Proposed Revisions to a Standard Plans Index

Index Number: 700-012

Index Title: Single Post Bridge Mounted Sign Support

All Sheets: Renamed Index "Single Post Sign Support Barrier Side-Mounted".

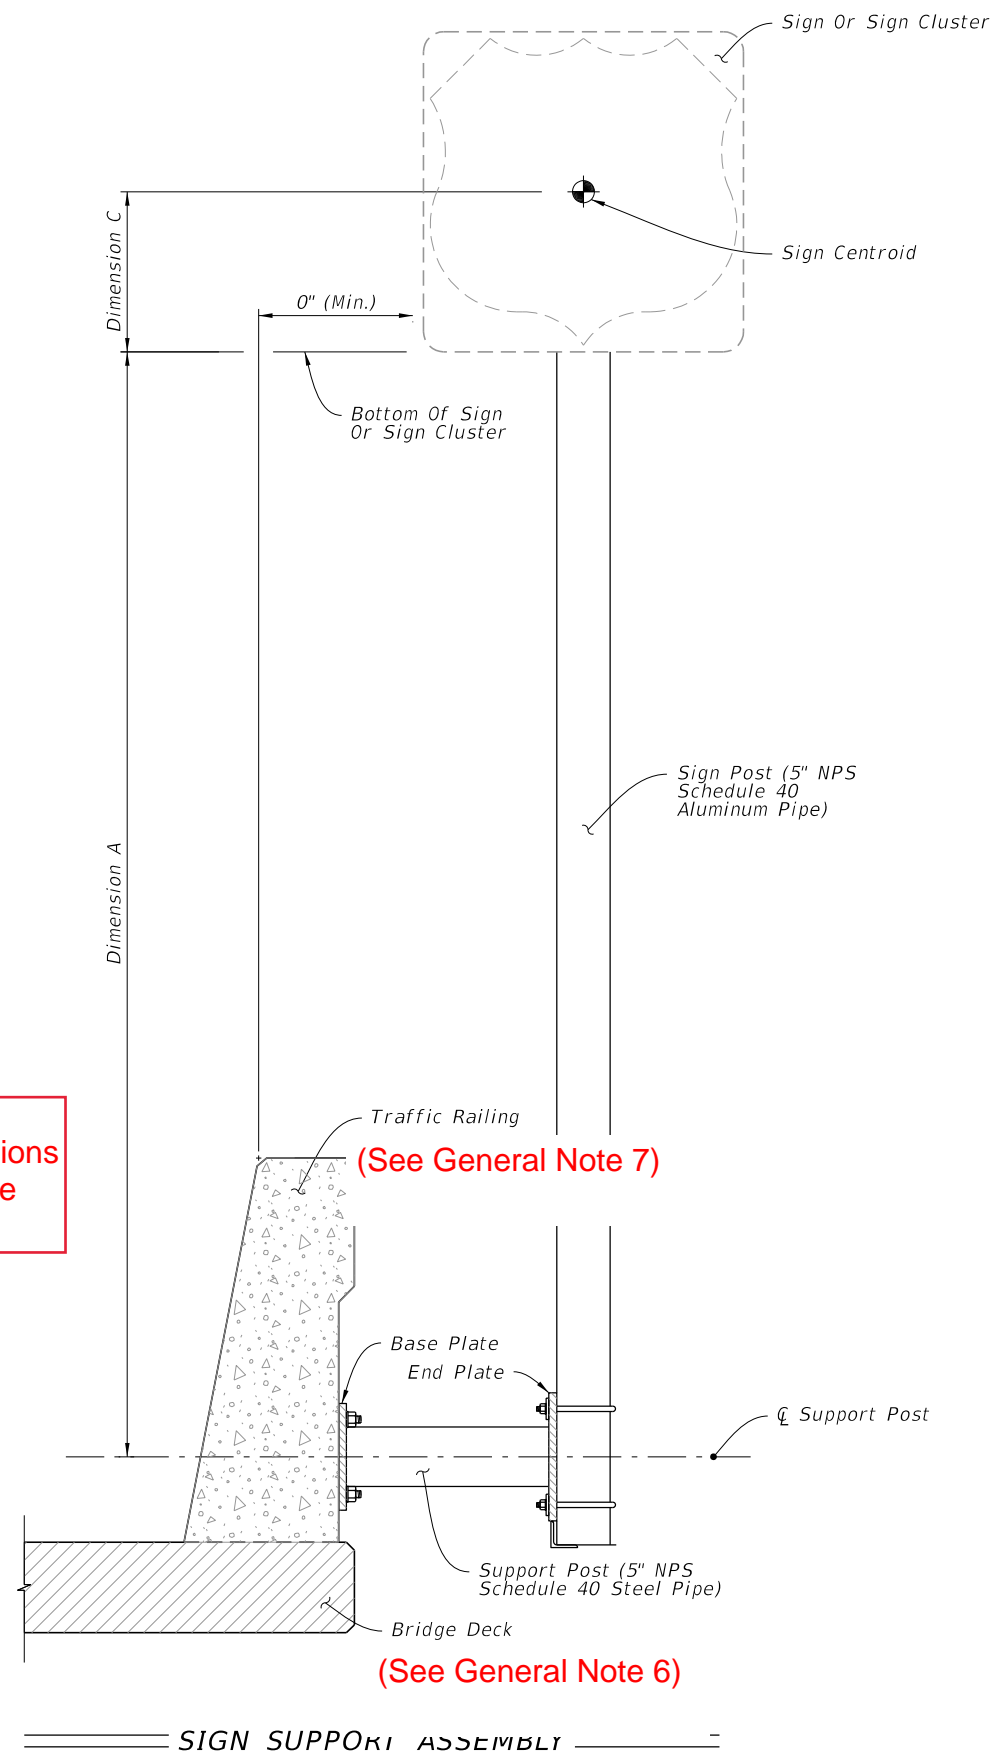
Sheet 1: Updated Notes to General Notes; Added New Note 1 - "Meet the requirements of Specification 700".; Deleted Note 3; Moved Note 4 to Specification 962; Deleted Note 5; Renumbered Notes; Added New Notes from Sheet 2, Note 6 - "Bridge deck shown, approach slabs, junction slabs, and miscellaneous structures are similar." and Note 7 - "Traffic railings are shown. Concrete barriers and parapets are similar."; Updated the General Note references in the SIGN SUPPORT ASSEMBLY detail.

UPDATED: GENERAL NOTES:

~~NOTES:~~

- ~~1. Work with Index 700-010.~~
- ~~2. Shop Drawings: Not required.~~

ADDED NEW NOTE 1: Meet the requirements of Specification 700.

~~3. Materials:~~

- ~~A. Steel Plate: ASTM A36 or ASTM A709 Grade 36~~
- ~~B. Steel Pipe (Support Post): ASTM A501 Schedule 40~~
- ~~C. Aluminum Pipe: ASTM B429 Alloy 6061-T6~~
- ~~D. Galvanized U-Bolts, Nuts and Plate Washer~~
 - ~~a. U-Bolts: ASTM A449~~
 - ~~b. Hex Nuts: ASTM A 563 Lock Nuts~~
 - ~~c. Plate Washer: ASTM A 36 or ASTM A709 Grade 36 or 50~~
- ~~E. Galvanized Anchor bolts, Nuts and Washers:~~
 - ~~a. Anchor Rod: ASTM F1554 Grade 55 fully threaded (for Adhesive Anchors)~~
 - ~~b. Anchor Bolts: ASTM F1554 Grade 55 Grade A Hex~~
 - ~~c. Nuts: ASTM A563 Heavy Hex Locking~~
 - ~~d. Washers: ASTM F436~~
- ~~F. Adhesive Anchor Bonding Material: Specification 931 Type HV Adhesive.~~
- ~~G. Weld Material: E70XX~~
- ~~H. Snap-In Post Cap: UV and weather-resistant glass-filled polyester cap~~

DELETED

~~4. Coating:~~

- ~~A. U-Bolts, Threaded Rods, Nuts and Washers: ASTM F2329~~
- ~~B. Other Steel: ASTM A123~~

~~5. Fabrication:~~

- ~~A. Weld: Specification 460-6.4~~
- ~~B. Hot dip galvanize after fabrication~~

GENERAL COMMENT: Material and fabrication information was deleted. Information is either already covered in Standard Specifications OR will be added to Section 700, 962 or 965 in conjunction with these revisions.

~~4. Construction:~~

- ~~A. Locate Sign Support a minimum of 5 feet from an open joint or transition (sign stationing may be adjusted to accommodate this requirement).~~
- ~~B. Base plate must be flush with back of Traffic Railing~~
- ~~C. Anchors in Traffic Railings:~~
 - ~~a. Install Adhesive Anchors in accordance with Specification 416 except perform field test on one anchor per sign support location.~~
 - ~~b. Use templates and tie anchors as necessary to maintain correct placement of C-I-P Embedded Anchors~~
 - ~~c. Do not drill into existing conduit~~
- ~~D. Temporary Signs on Permanent Traffic Railings: Same as Permanent except Field testing of anchors is not required~~

~~5. Removal of Temporary Signs on Permanent Traffic Railings:~~

- ~~A. Cut anchor rods flush with the top of the traffic railing~~
- ~~B. Coat anchors with Type F-1 epoxy to prevent corrosion~~
 - ~~a. Extend coating 2 inches beyond edge of cut anchor rods~~
 - ~~b. Epoxy coating 1/16" thick minimum~~

~~8. Payment:~~

~~Include the cost of all materials and labor in the cost of the single post sign assembly.~~

DELETED

ADDED NEW NOTE 6 AND 7 FROM SHEET 2:
 6. Bridge deck shown. Approach slabs, junction slabs, and miscellaneous structures are similar.

7. Traffic railings are shown. Concrete barriers and parapets are similar.

CHANGED TITLE:
 Single Post Sign Support Barrier Side-Mounted

LAST REVISION	DESCRIPTION
11/01/17	
11/01/22

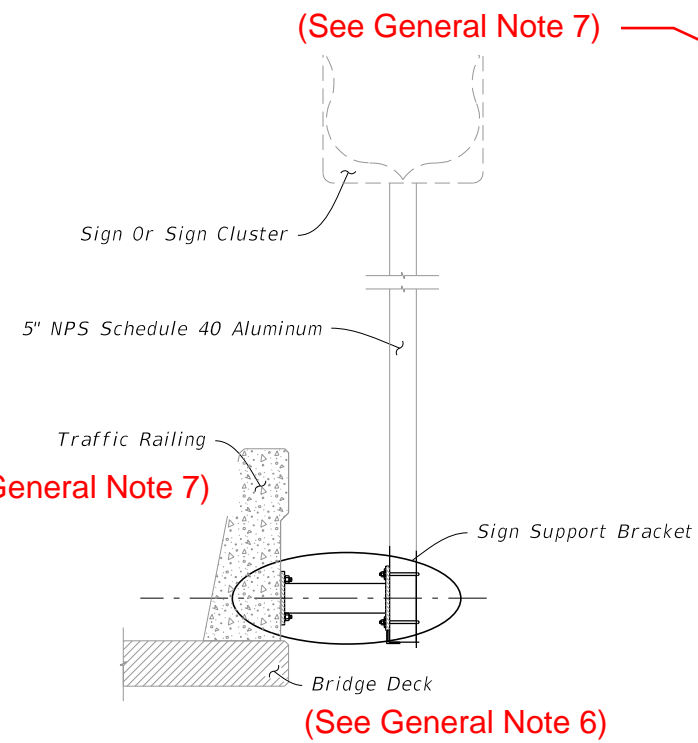
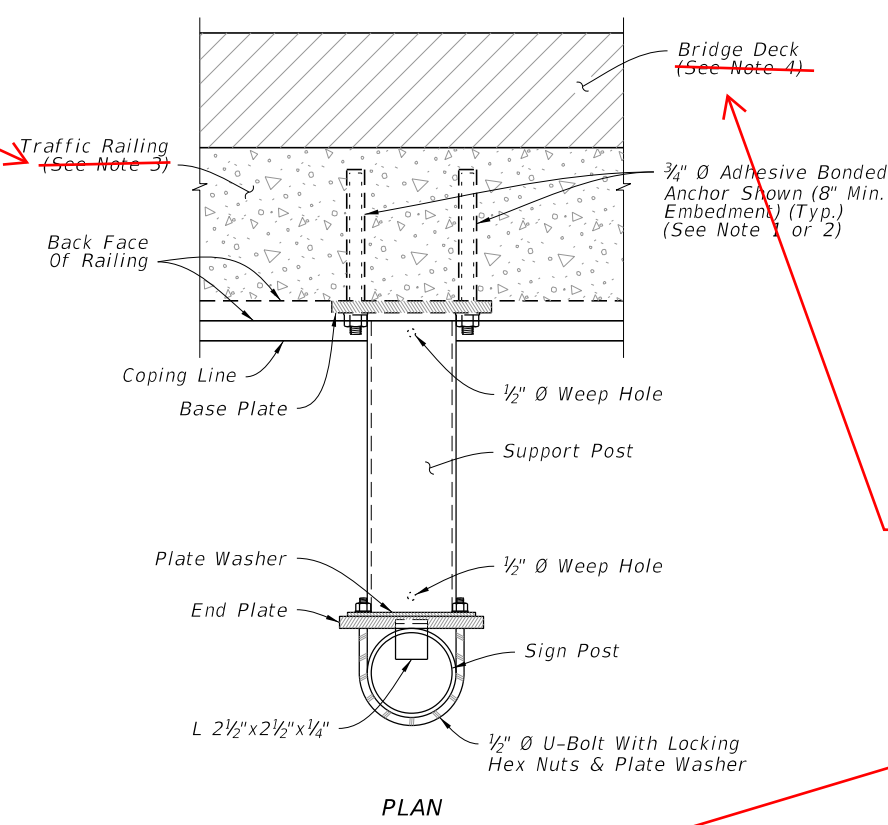
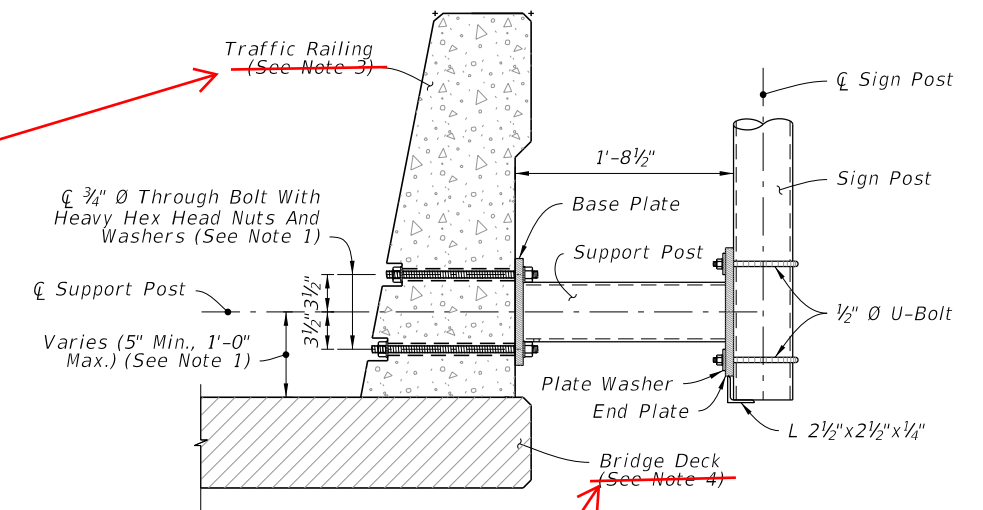
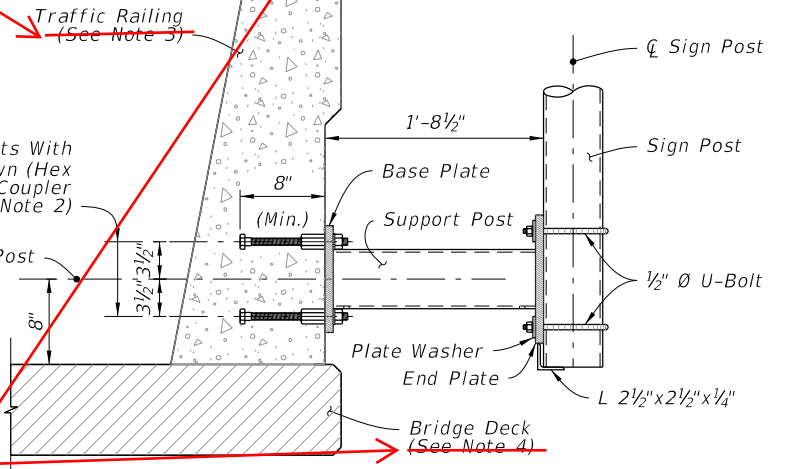
Sheet 2: Moved Notes 3 and 4 to the General Notes on Sheet 1; Updated General Note references.

(See General Note 7)

(See General Note 6)

(See General Note 6)

- New Traffic Railings:
 - Optional Couplers are shown for slipforming; keep Anchor Bolt coupler threads free of concrete.
- ~~36" Single-Slope Traffic Railing shown, other Traffic Railings and Parapets are similar.~~

- ~~Bridge Deck shown, Approach Slab and Retaining Wall are similar.~~

MOVED TO GENERAL NOTES

CHANGED TITLE:
Single Post Sign Support Barrier Side-Mounted

SHEET
3 of 3

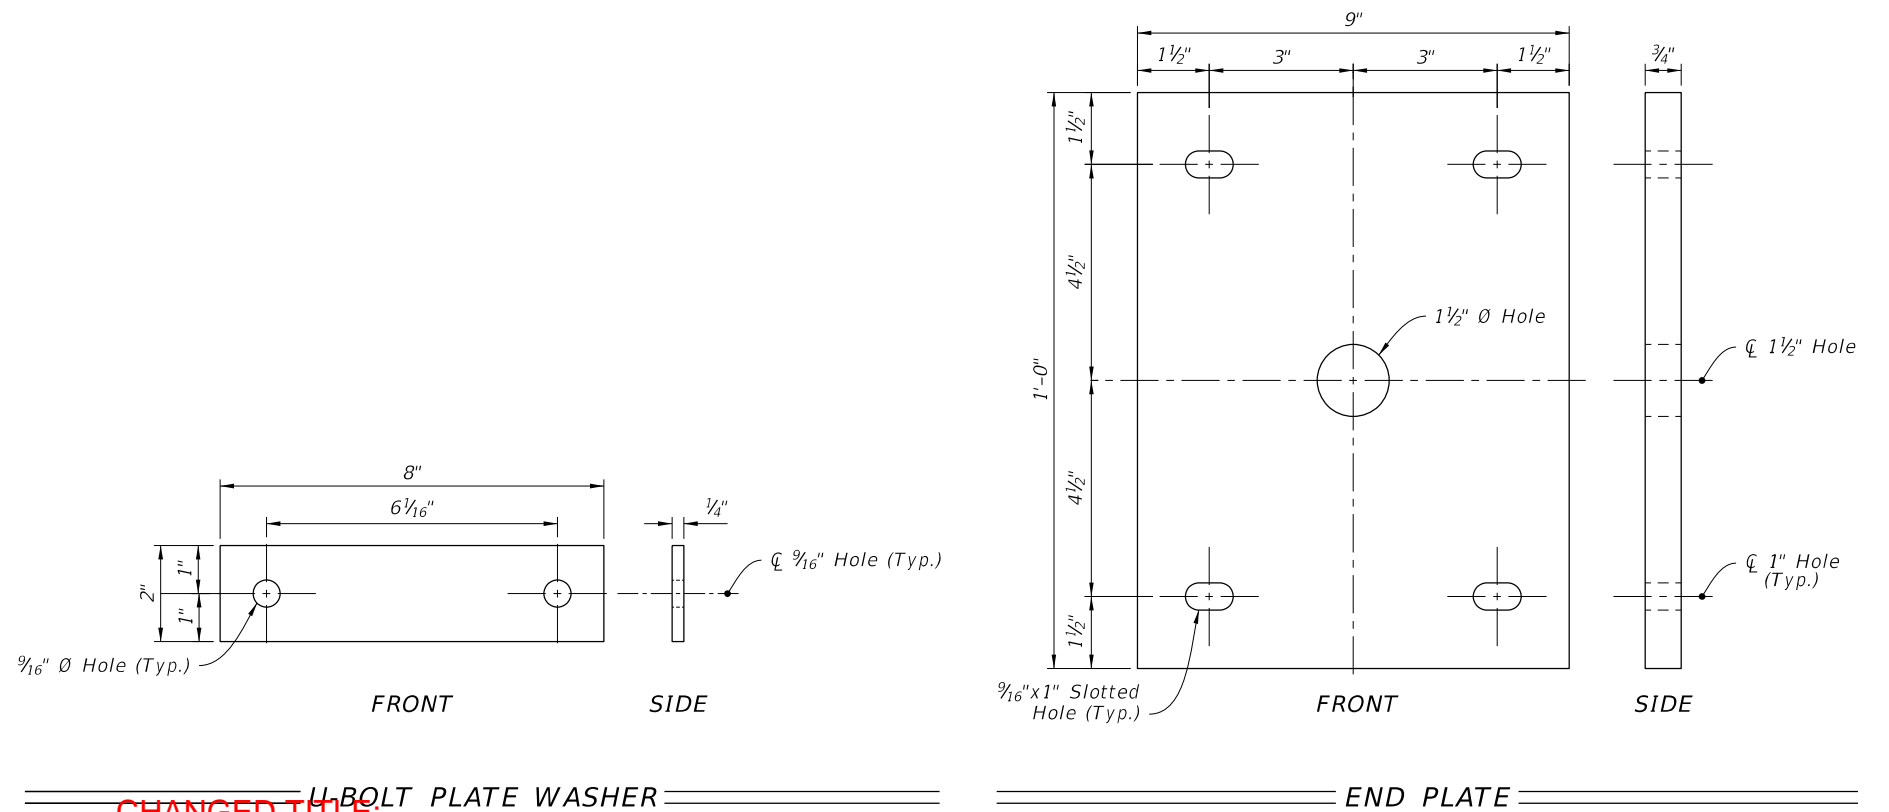
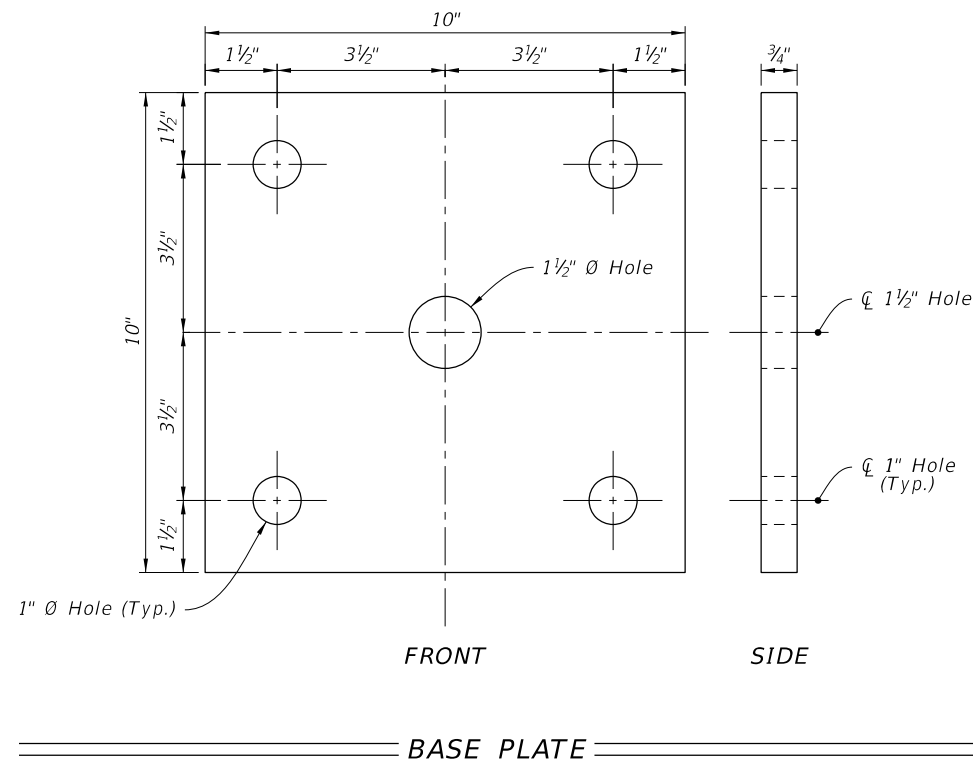
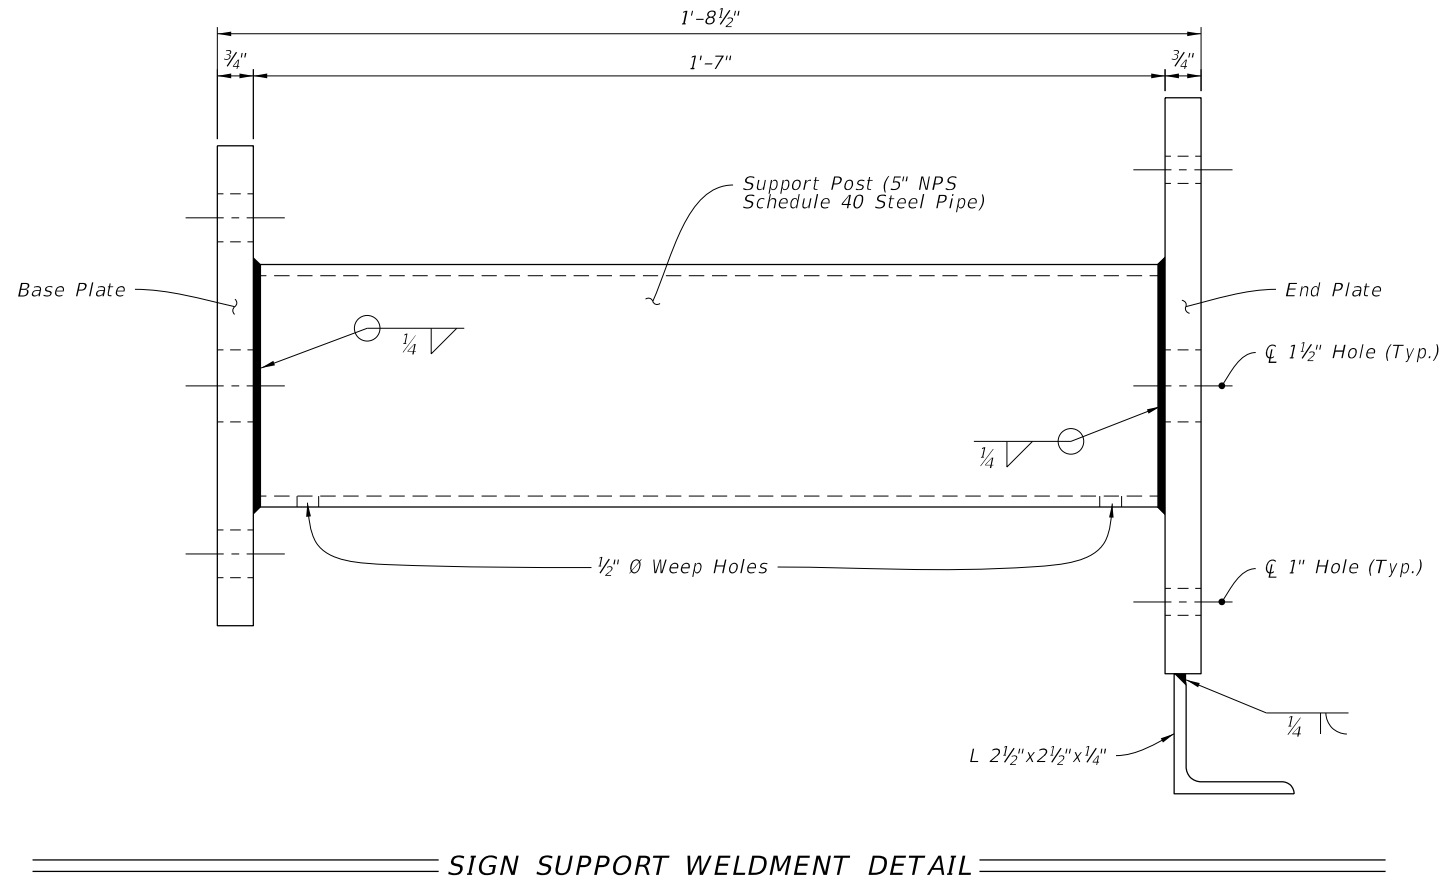
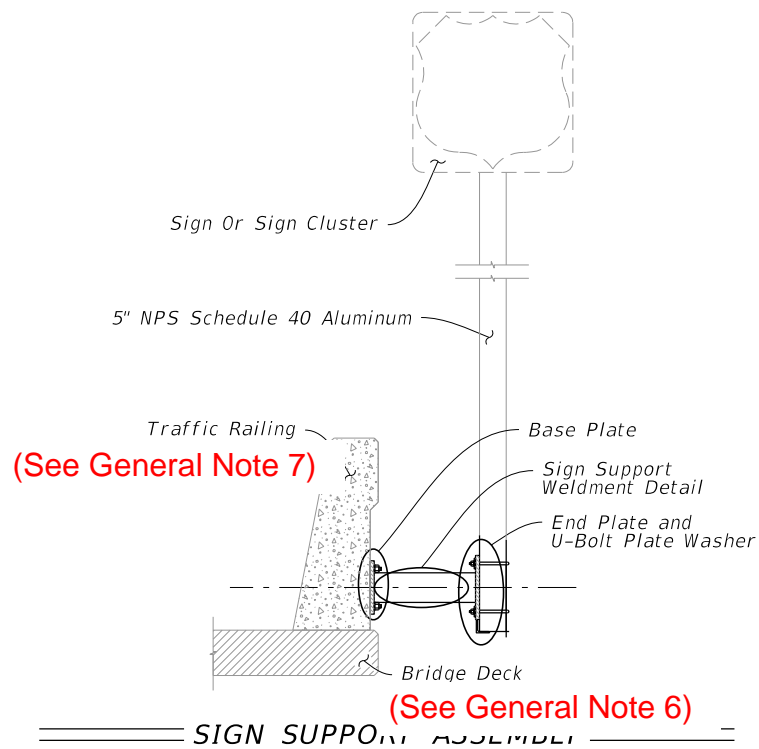
Sheet 3: Updated the General Note references in the SIGN SUPPORT ASSEMBLY detail.

CHANGED TITLE:
Single Post Sign Support Barrier Side-Mounted

~~SINGLE POST BRIDGE MOUNTED SIGN SUPPORT~~
